DELEGATED APPLICATION REPORT

Address: 55 Vastern Road, Reading, RG1 8BU

Application No: PL/24/0872

Proposal: Non-material amendments to permission 231673 (granted on 27/03/2024) to alter the wording of Conditions 2 (approved plans) and 35 (vehicle parking spaces) to provide reconfigured cycle, refuse and plant store rooms, changes to windows/doors and associated alterations, all within Blocks B-F (amended description).

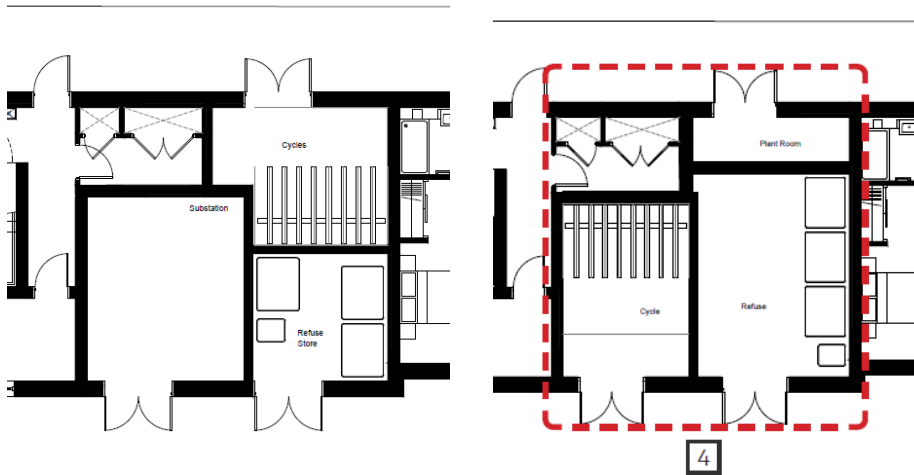
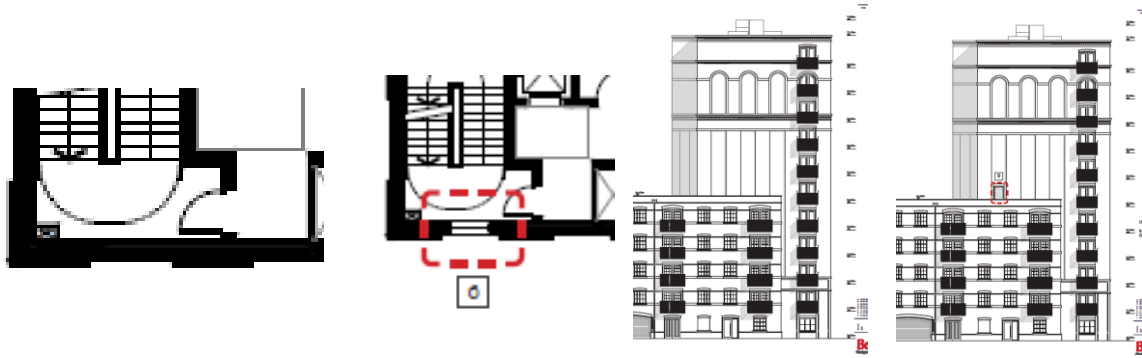
- i. The proposed changes are detailed at section 2 above. These are considered in-turn, with the explanations and justifications provided by the applicant also referenced where relevant too.
- ii. Refuse door serving Block B at ground floor level moved further east and associated alterations to the internal layout of the refuse storage area.

- iii. RBC Waste Services raise no objections to this proposed change, with refuse vehicles primary access point for collection remaining on the west elevation (unchanged, as shown above). Although this change reconfigures the layout of the refuse store, there is no change in the overall number of bins being provided. Accordingly, no concerns are raised.
- iv. Reconfiguration of cycle and waste storage areas and substation space serving Block C, including both cycle and waste stores fronting onto the north-south route, with the substation now being accessed from the east (rear) elevation rather than the west.

- v. RBC Waste Services and RBC Transport raise no issues with these proposed changes. For future occupiers, the location of the cycle store fronting onto the main north-south route through the site, rather than the rear of the building, is advantageous. The substation is reduced in area, with this being relocated to Block D instead. There are no external changes proposed as part of this alteration, with it solely relating to internal reconfiguration works.
- vi. Window added to west elevation of Block B at fifth floor level, to provide emergency access to the roof terrace.

Block B roof access windows

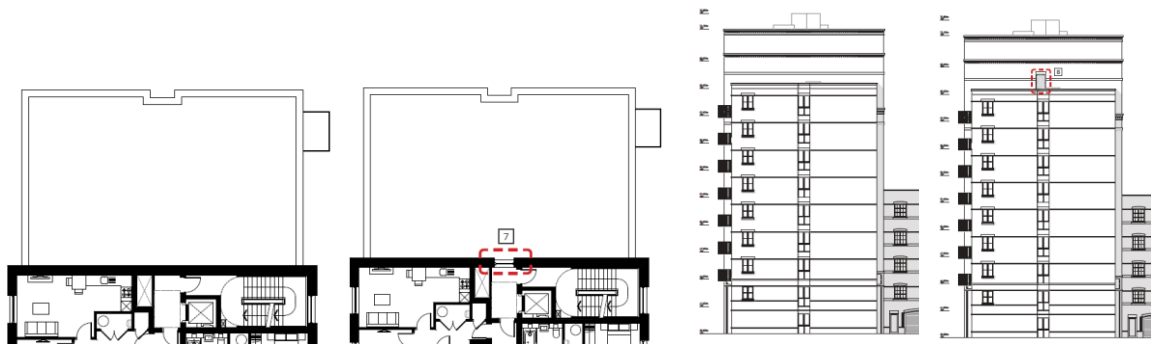
The windows proposed for roof access on block B are fully openable obscured windows that will be locked and accessible to maintenance personnel only. The cill is proposed at approximately 450mm from the finished floor level, therefore the windows will not be classified as doors. Windows will be locked secured at all times.

- viii. The access point is from the staircase and it is not considered to raise any design or amenity issues. Although it will be a single opening on this part of the façade of the window, it is a minor addition in the context of the elevation as a whole. It is required in the interests of maintaining the roof space, which has arisen as a result of normal design development post the original planning permission. Accordingly, this component of the proposals is considered appropriate.
- ix. Window added to east elevation of Block B at ninth floor level, to provide emergency access to the roof terrace.

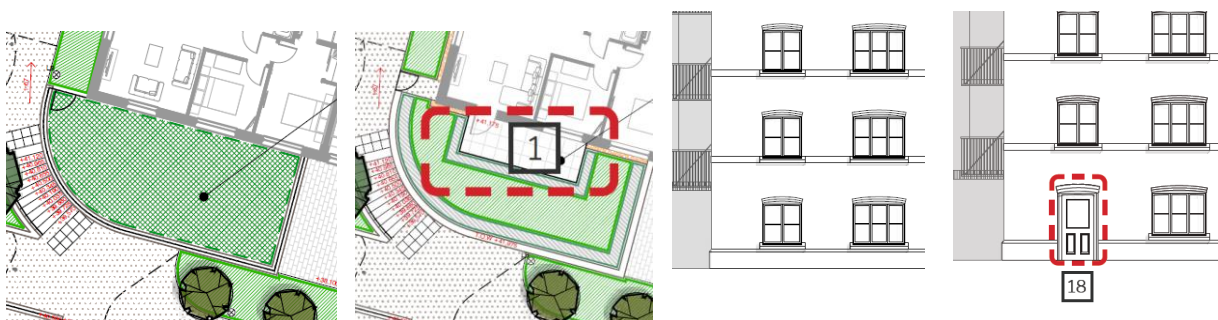
- xii. A variety of changes are proposed at this point of the building, although externally these changes are limited to three windows altering into ventilation grills (see above) on the west elevation and one additional ventilation grill on the south elevation. These are required to adhere to separate fire regulations, serving plant rooms and the refuse store. Whilst utilitarian in appearance, they are not considered to unduly compromise the overall design idiom of these facades of the building and are, in reality, a necessary component part of any building of this nature. No design, amenity or other impacts are envisaged. As a result of these changes the waste and cycle stores are being reconfigured, but like the other blocks this does not result in a reduction in provision, as detailed by the applicant below:

- xiii. RBC Waste Services and RBC Transport raise no issues with these proposed changes. For future occupiers, the facilities are on a par with the originally approved layout. All other changes at these points (shown above in the comparative floor plan) are minor in nature and no concerns are raised.

Block D terrace access

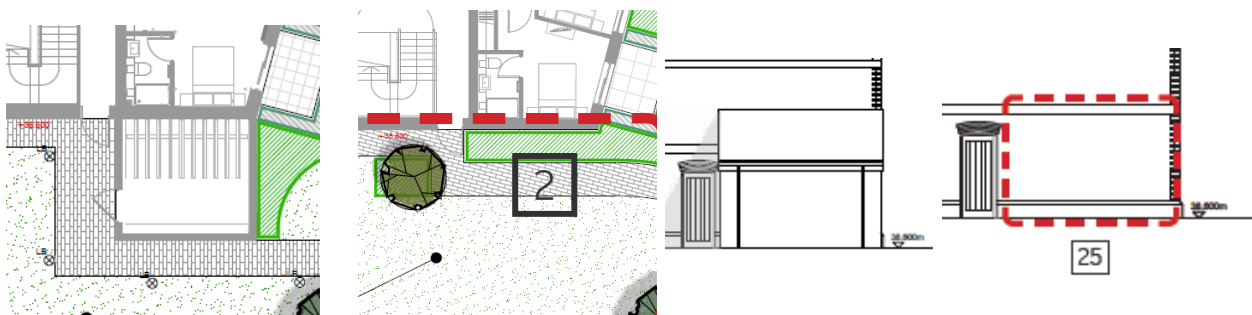
- xiv. External private terrace for one residential unit added to the flat roof above the undercroft vehicle access to Block D (west elevation), with an alteration of a window to a door to enable access.

During detailed design stage, it has been confirmed that the roof of the under-croft vehicular access has an opportunity to be designed as an accessible flat roof. Hence apartment on the podium level of block D is proposed to be given an external amenity space. Access to this space would be provided via door from the living room instead of a current window, which would be in keeping with the approved elevation, in keeping with the rhythm of the elevational openings and overall style and design. The terrace is proposed to be enclosed with railing and surrounded by hedgerow. Majority of the roof would be planted with amenity shrub mix and hedgerow around the roof's edge. The planting would create a wide buffer and provide privacy to the terrace. The setback of the terrace behind the thick planting would ensure the potential overlooking to and from the neighbouring property is mitigated. Landscaping is proposed to be maintained by a management company ensuring the planting is well looked after. A separate access for the management company would be provided via secured gates from the podium level, as shown on drawing "448.LA.101 Landscape General Arrangement plan".

- xv. This proposed change (shown above in plan/elevation form, with the justification by the applicant also detailed above) creates an external amenity area for one first floor flat adjacent to the switchback access in front of Block D. This is a 2-bed unit, with the width of the terrace extending between the living room and one bedroom, but set back from the second bedroom or the separate unit further south, meaning overlooking from the terrace towards the separate flat to the south is not envisaged at a significant level. Whilst the door does not particularly align with the character of the fenestration in the remainder of the façade, it is not considered harmful enough to warrant resisting this proposal on this basis. The external space will improve the quality of accommodation for this residential unit. It is also noted that the terrace will reduce the amount of soft landscaping at this point, but does not undermine the overall landscaping strategy.

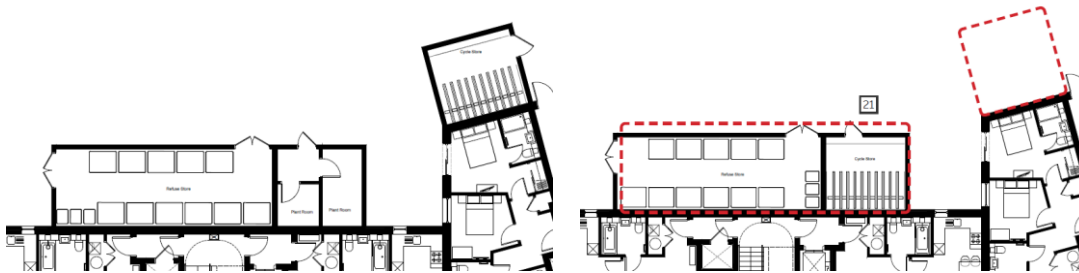
- xvi. Ground floor cycle store omitted from the west elevation of Block E and replaced with soft landscaping and altered path arrangement and one additional tree.

- xvii. This structure has been omitted, with the cycle parking provided elsewhere (to the south – see below). As a consequence additional soft landscaping is proposed and the path at this point is reconfigured, with the addition of one tree too. These are all logical moves following the removal of

this structure and raise no issues, with the tree located adjacent to a stairwell (rather than outside a habitable window). These proposed changes are considered to be appropriate.
